<b>DEVELOPMENT NO.:</b>	21001488
<b>APPLICANT:</b>	Bradford Homes
<b>ADDRESS:</b>	9 FIRST AV GLENELG EAST SA 5045
<b>NATURE OF DEVELOPMENT:</b>	Two storey detached dwelling and outbuilding in rear yard
<b>ZONING INFORMATION:</b>	<p><b>Zones:</b></p> <ul style="list-style-type: none"> <li>• Established Neighbourhood</li> </ul> <p><b>Overlays:</b></p> <ul style="list-style-type: none"> <li>• Airport Building Heights (Regulated)</li> <li>• Affordable Housing</li> <li>• Building Near Airfields</li> <li>• Character Area</li> <li>• Hazards (Flooding - General)</li> <li>• Key Railway Crossings</li> <li>• Prescribed Wells Area</li> <li>• Regulated and Significant Tree</li> <li>• Stormwater Management</li> <li>• Traffic Generating Development</li> <li>• Urban Tree Canopy</li> </ul> <p><b>Technical Numeric Variations (TNVs):</b></p> <ul style="list-style-type: none"> <li>• Minimum Frontage</li> <li>• Minimum Site Area</li> <li>• Maximum Building Height (Levels)</li> </ul>

<b>LODGEMENT DATE:</b>	22 March 2021
<b>RELEVANT AUTHORITY:</b>	Assessment panel
<b>PLANNING &amp; DESIGN CODE VERSION:</b>	19 March 2021 2021.2
<b>CATEGORY OF DEVELOPMENT:</b>	Code Assessed - Performance Assessed
<b>NOTIF

**DETAILED DESCRIPTION OF PROPOSAL:**

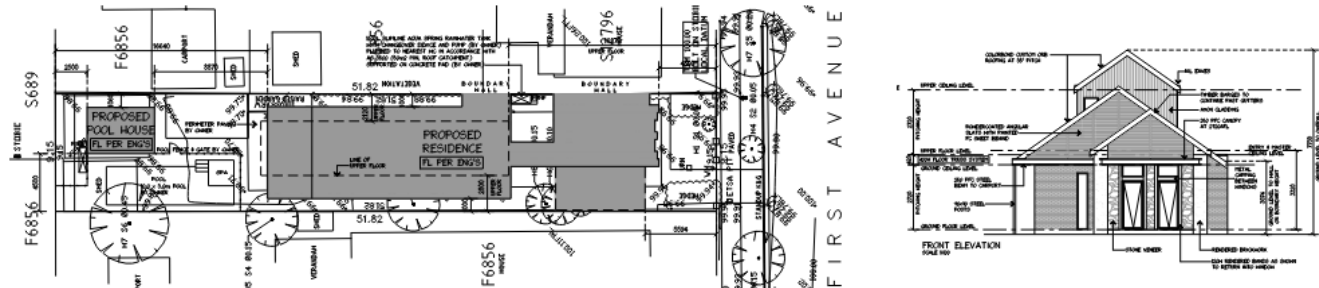
The development comprises the construction of a two storey detached dwelling, with the upper level partially contained within the roof space.

The roof has a high pitch (35 degrees) which is consistent with the pitches found in the locality, as well as providing clearances to accommodate the upper level. The wall height is 3.3 metres and the façade is clad in brick, render and stone, which is consistent with the materials used on nearby buildings.

The upper-level wall sits behind a pair of pitched gables by a distance of 12 metres behind the front of the dwelling, therefore not obvious when viewed from the street.

The carport is attached to the side of the dwelling and an outbuilding is located in the rear yard.

**INTERNAL REFERRALS**

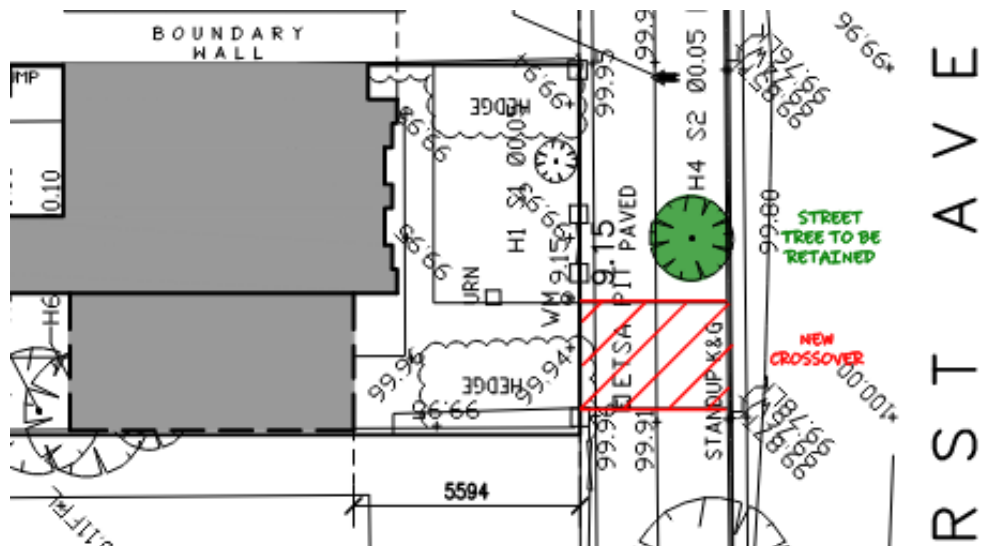
The proposal was referred to Council’s Technical Services area for the consideration of vehicle access and stormwater management. The site works plan demonstrates a satisfactory design for the retention/detention and outflow of water from the site. There is a street tree located 1.4 metres from the proposed crossover, which will be retained. Although the Design Code seeks a minimum clearance of 2 metres from the base of a tree, Council’s Arborist has confirmed the proposed distance is satisfactory. As mentioned, existing access is gained by an informal access driveway at the rear, which requires encroachment over private land without any formal arrangements by way of any right of ways. As the site is being redevelopment, access must be accommodated via an authorised entry point, in this case First Avenue. Given the physical constraints relating to access, the provision of a driveway whilst retaining the street tree is a positive outcome.
